ABSOLUTE SOLUTIONS INC.

UNIVERSAL ACCESS FUND RTP SITE VALIDATION & ACCEPTANCE REPORT

8 February 2021

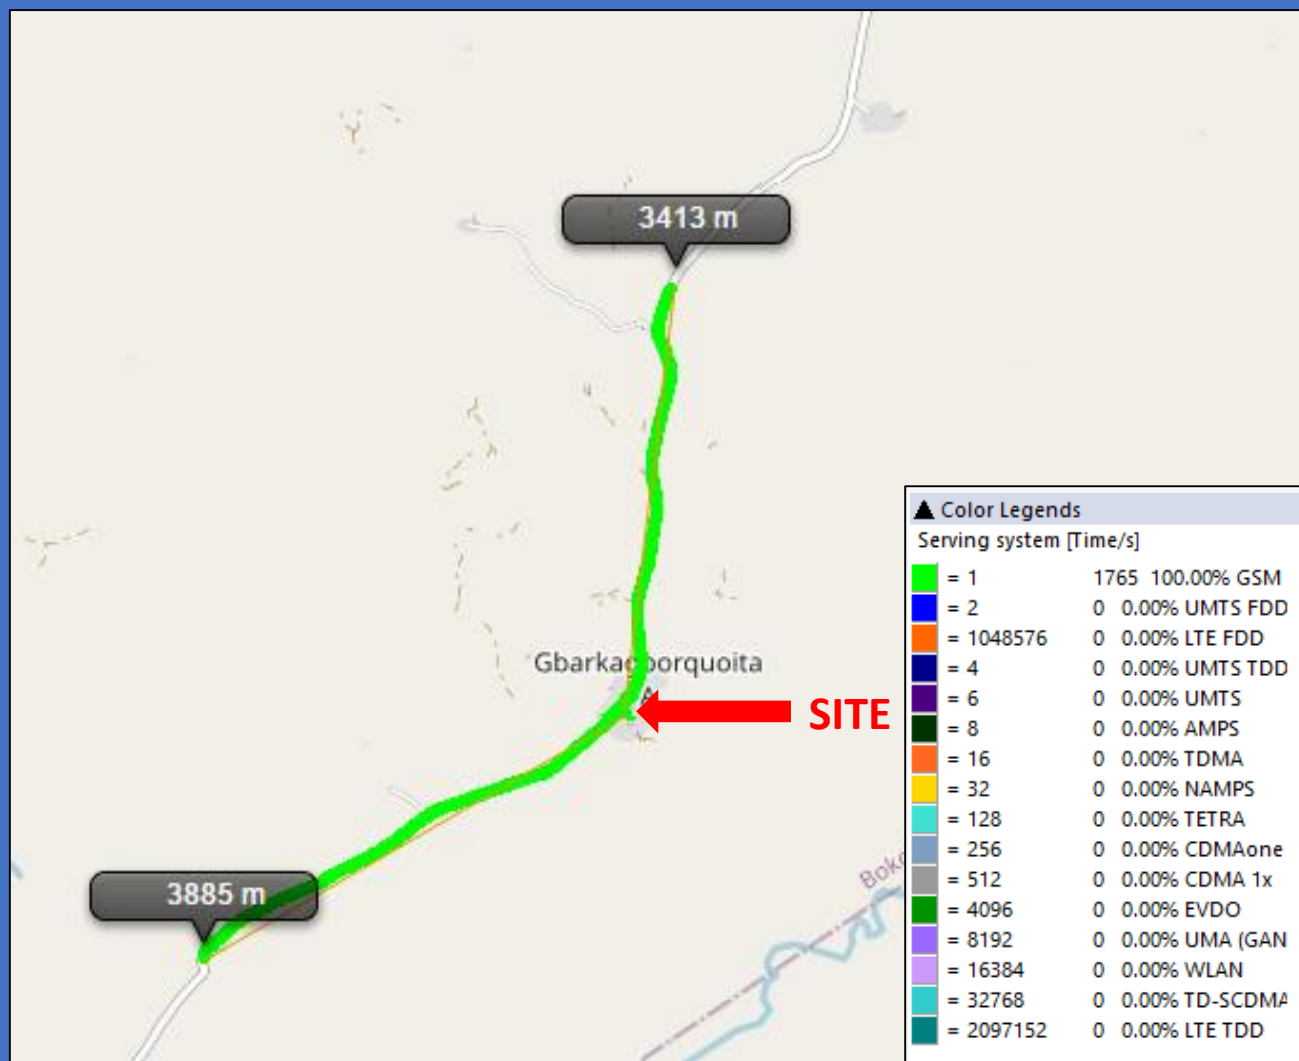
The site coverage radius is about 3.9 km with 100% in 2G network

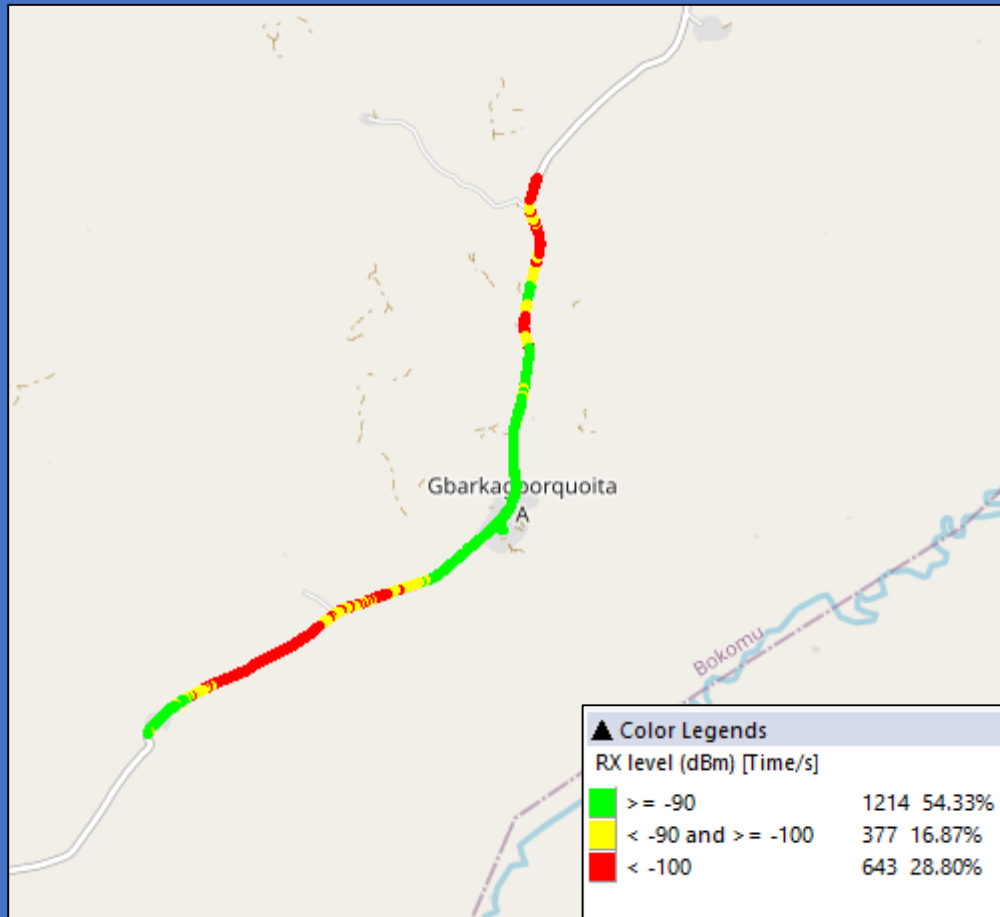
GSM coverage of the site is normal.

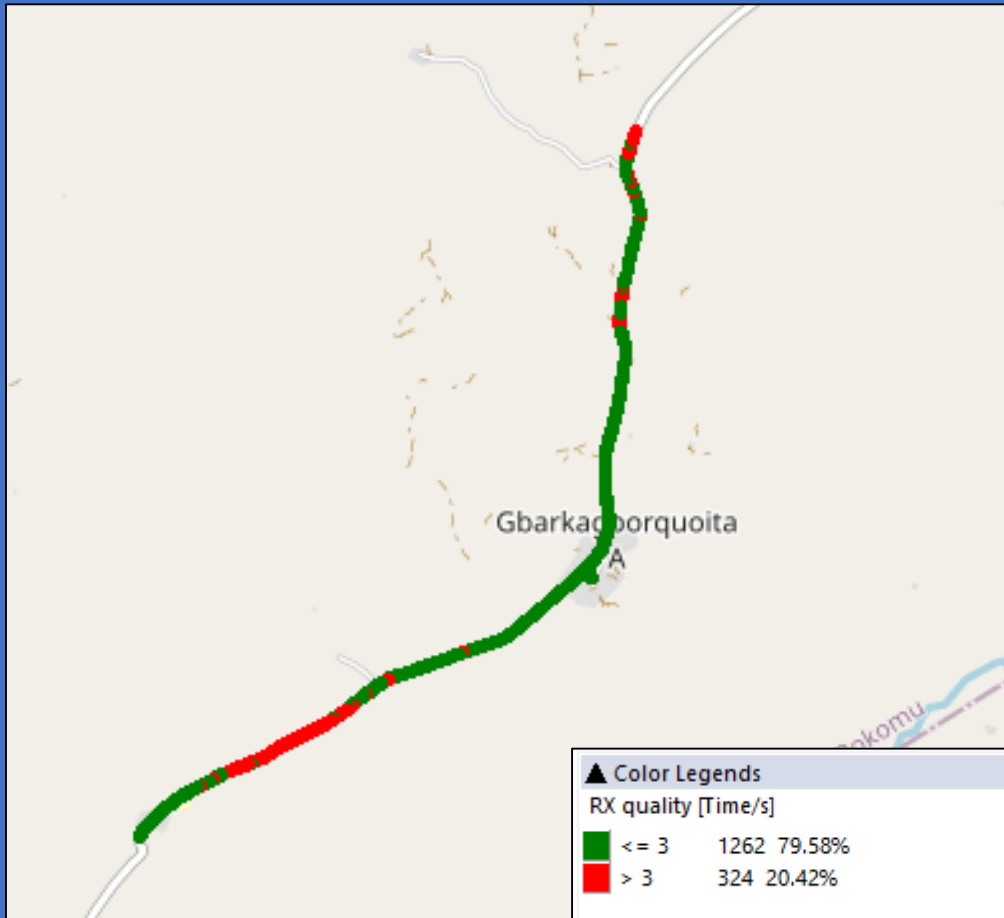
The site signal quality is normal.

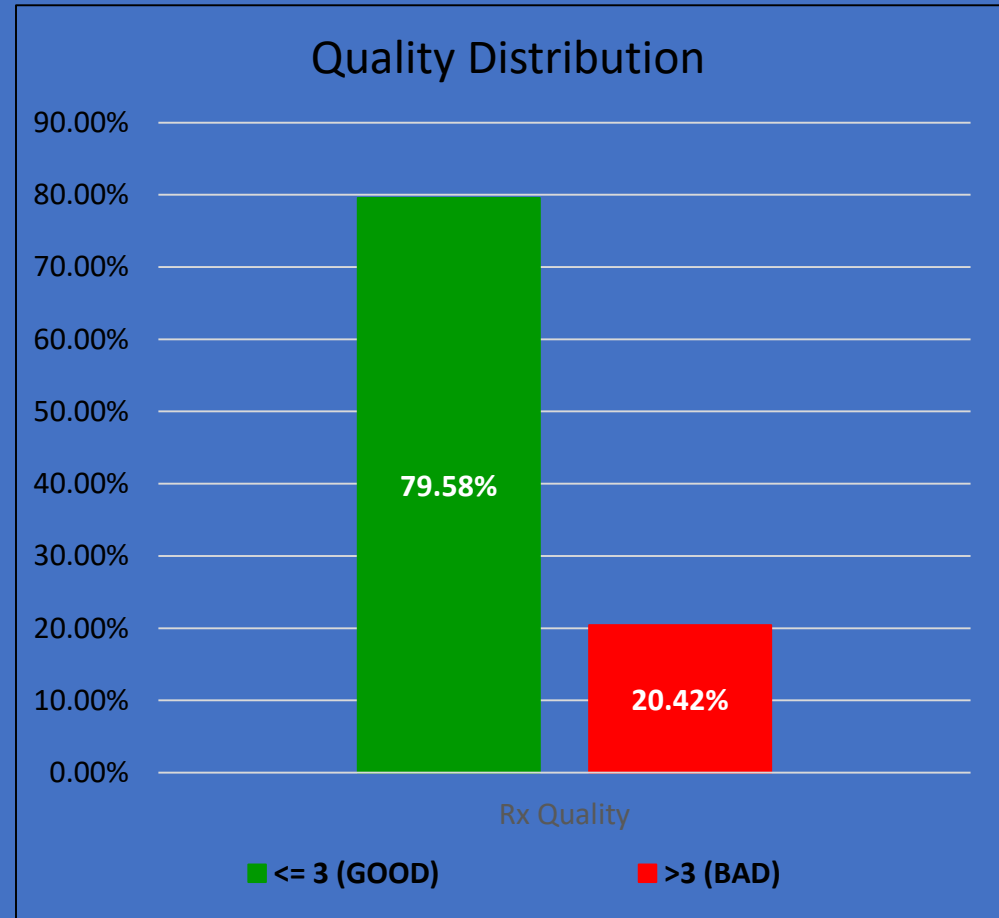
Signal Quality distribution. Bad quality originates from degradation in coverage.

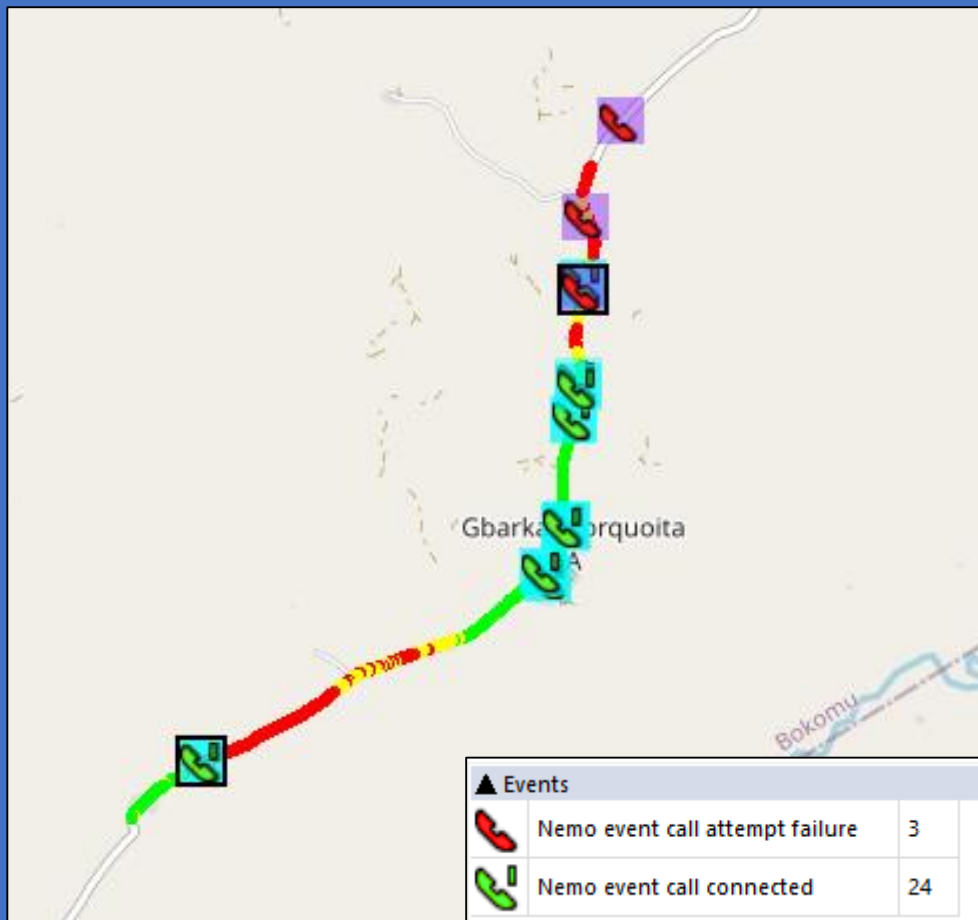
3 Call Setup failures; caused by weak signal level.

2 Calls dropped due to poor coverage.

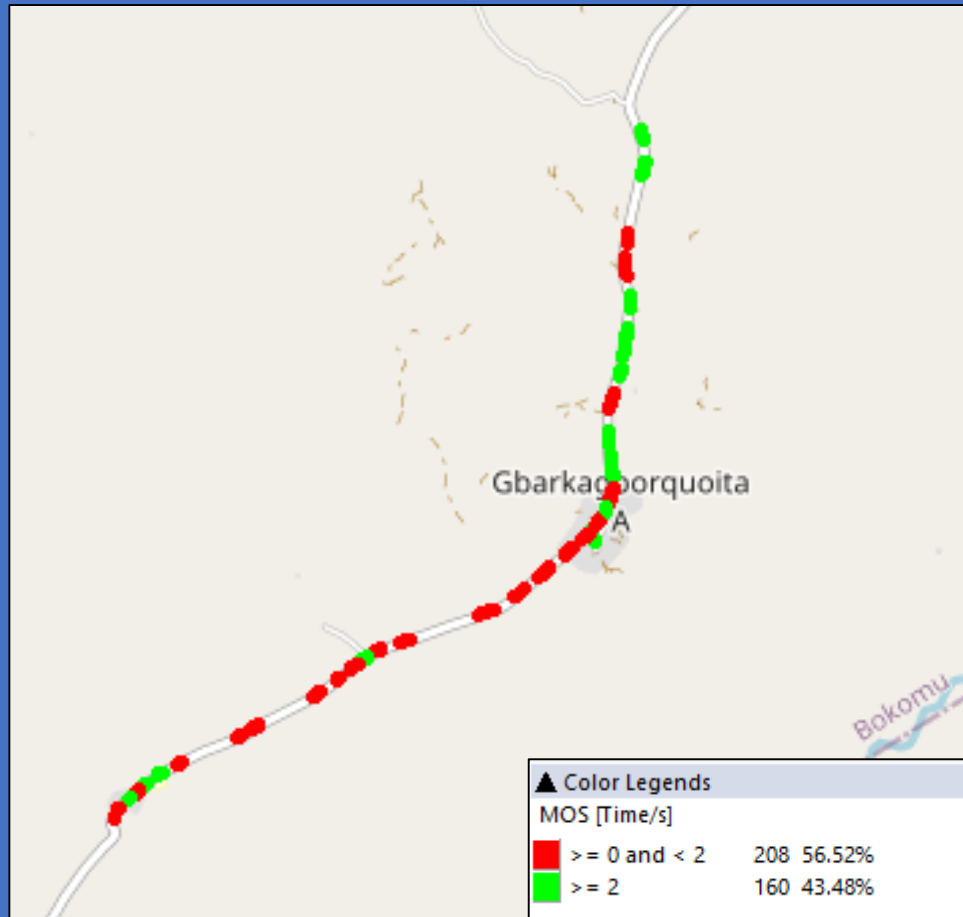
Voice Quality Score is below acceptable standards for most part of the test.

- Enable or check 2G EDGE parameter settings for internet connectivity.
- Check parameter settings to reduce call setup time to <15 sec.
- Check parameter settings to improve voice quality score.
- The site needs bi-annual maintenance.
- All metal tie wraps must to be replaced with rubber tie wraps, to meet telecommunications installation standard.
- All four legs of the tower need grounding.
- Bare grounding cables on the tower and in the cabinet must be changed to 72mm² coated grounding cable.
- Waveguide and jumper cables on RRUs need proper putty and tape for protection.
- Fabricated arm on the tower needs to be replace soon, else it will break, and the antenna will fall.
- Free hanging cables on the tower need cable holder.
- Grounding cables on fence should be 25mm² or 35mm² coated.
- Grounding test needs to be conducted for grounding system at the site.

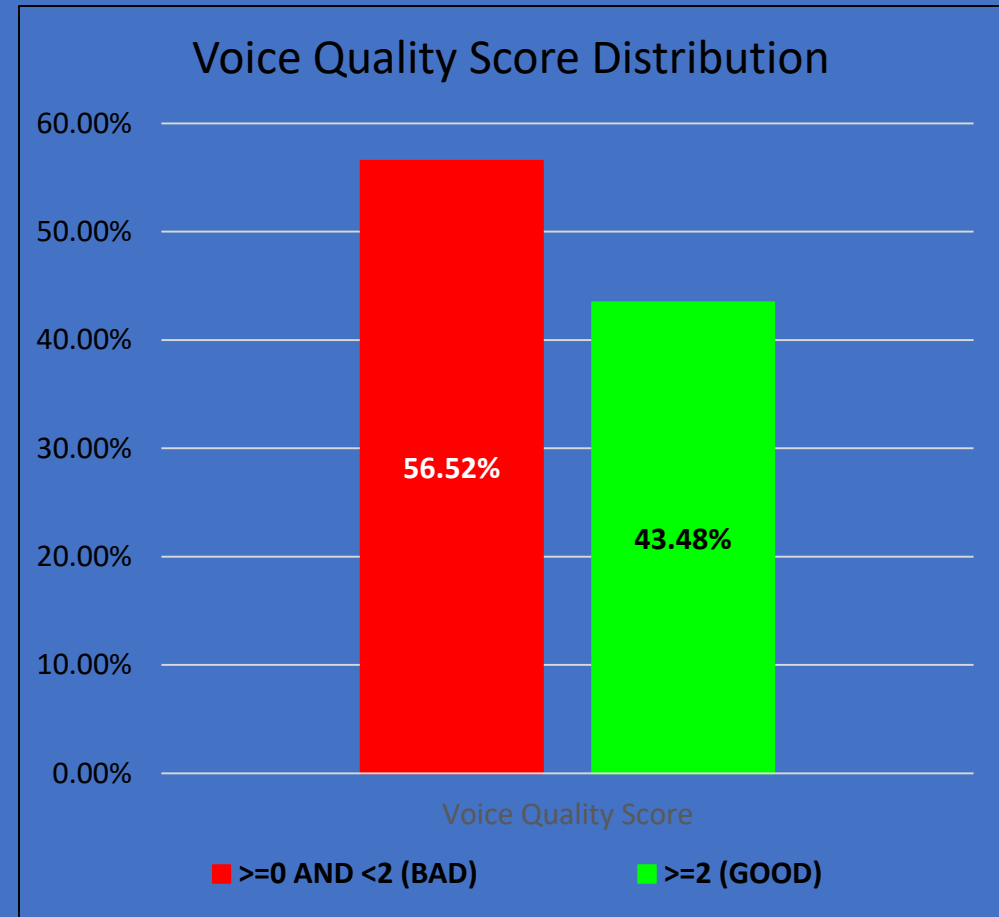
Almost 60% of the voice calls had poor voice quality

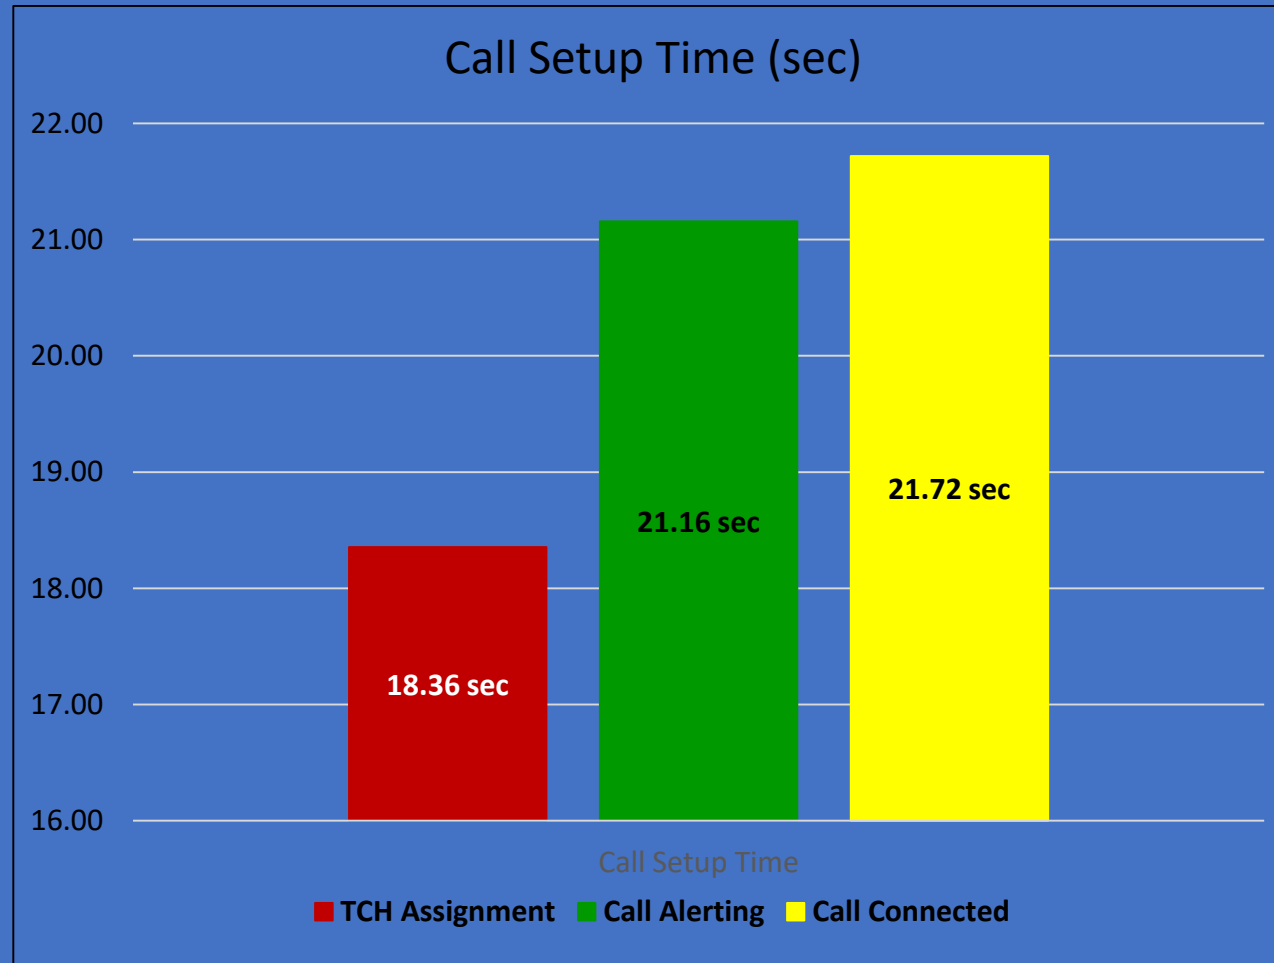
Average Call Setup Time is more than 2 times the normal (8 sec)

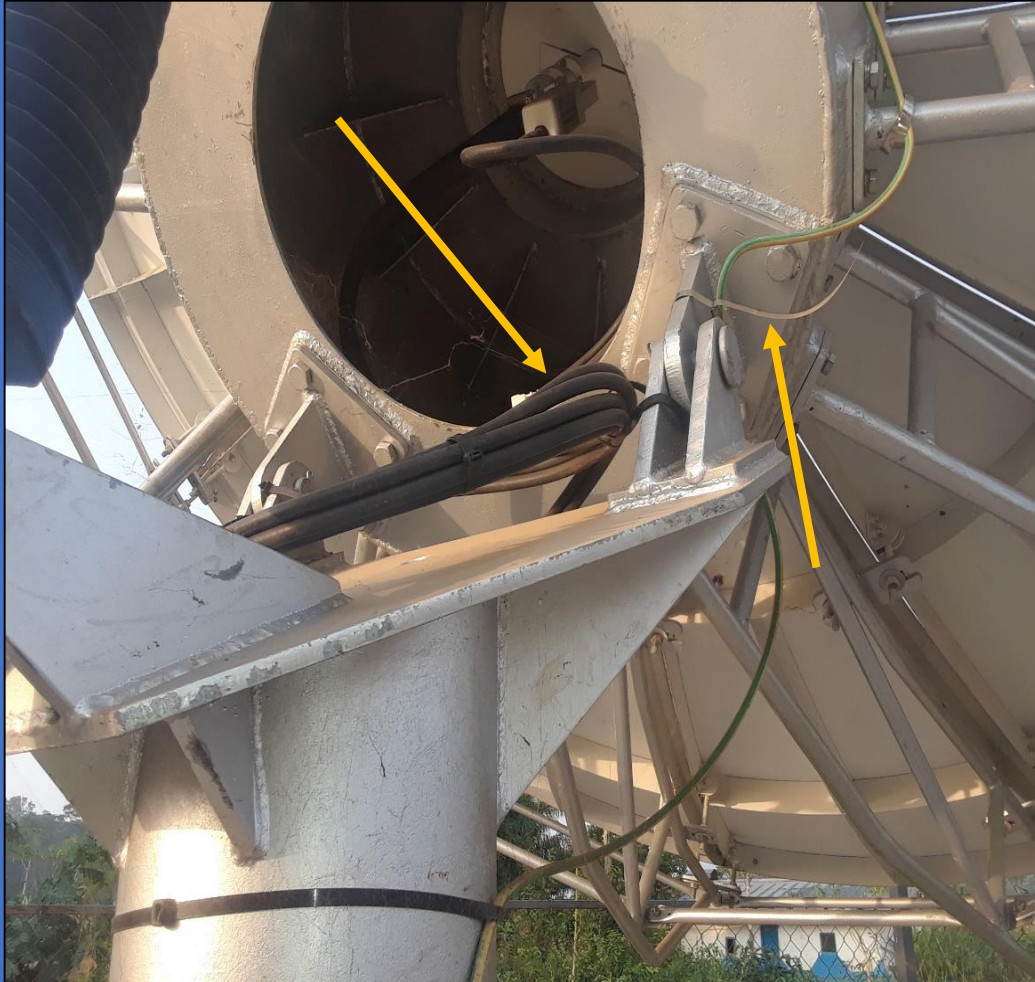
The jumper cables are scattered on the tower from the RRUs.

Improper taping of jumper cable from the antenna.

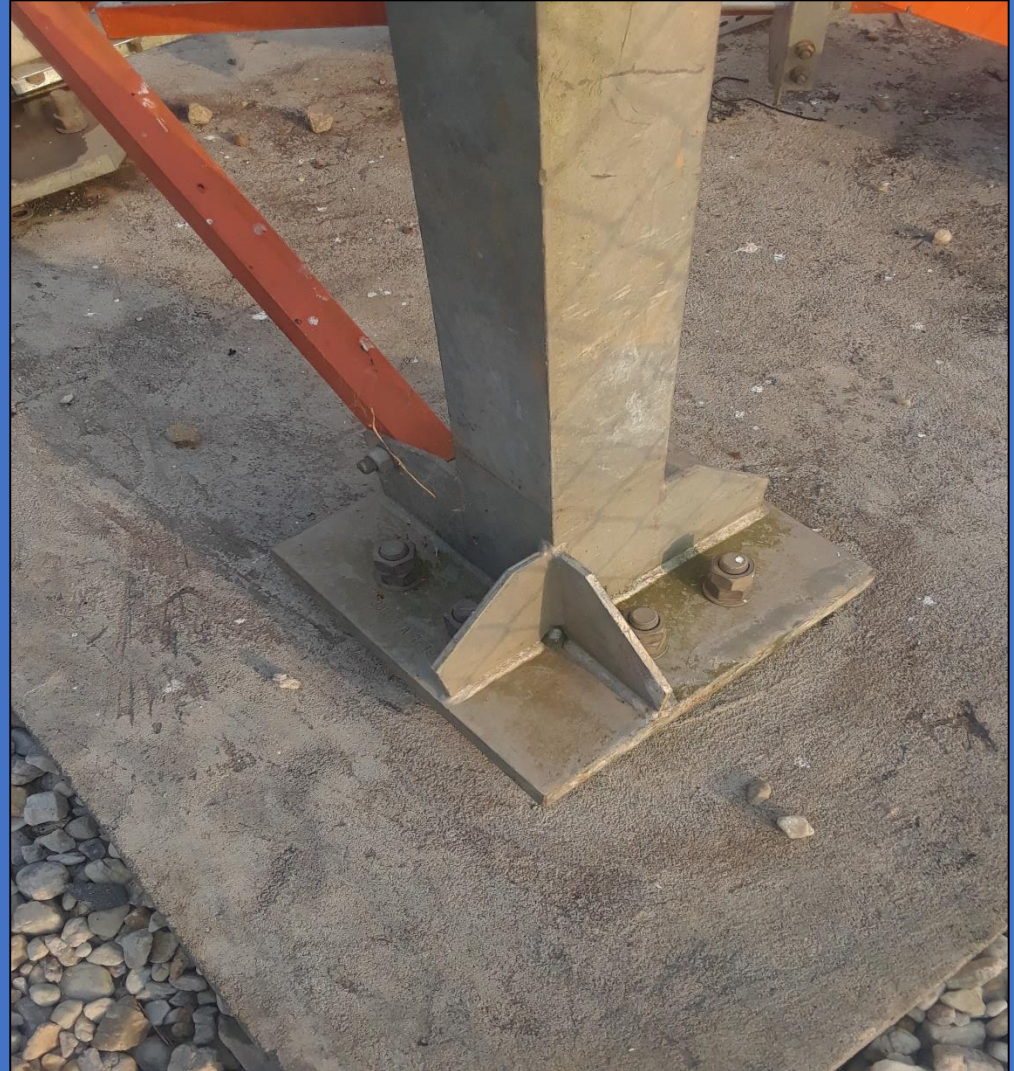
The IF cables on the tower are freely hanging.
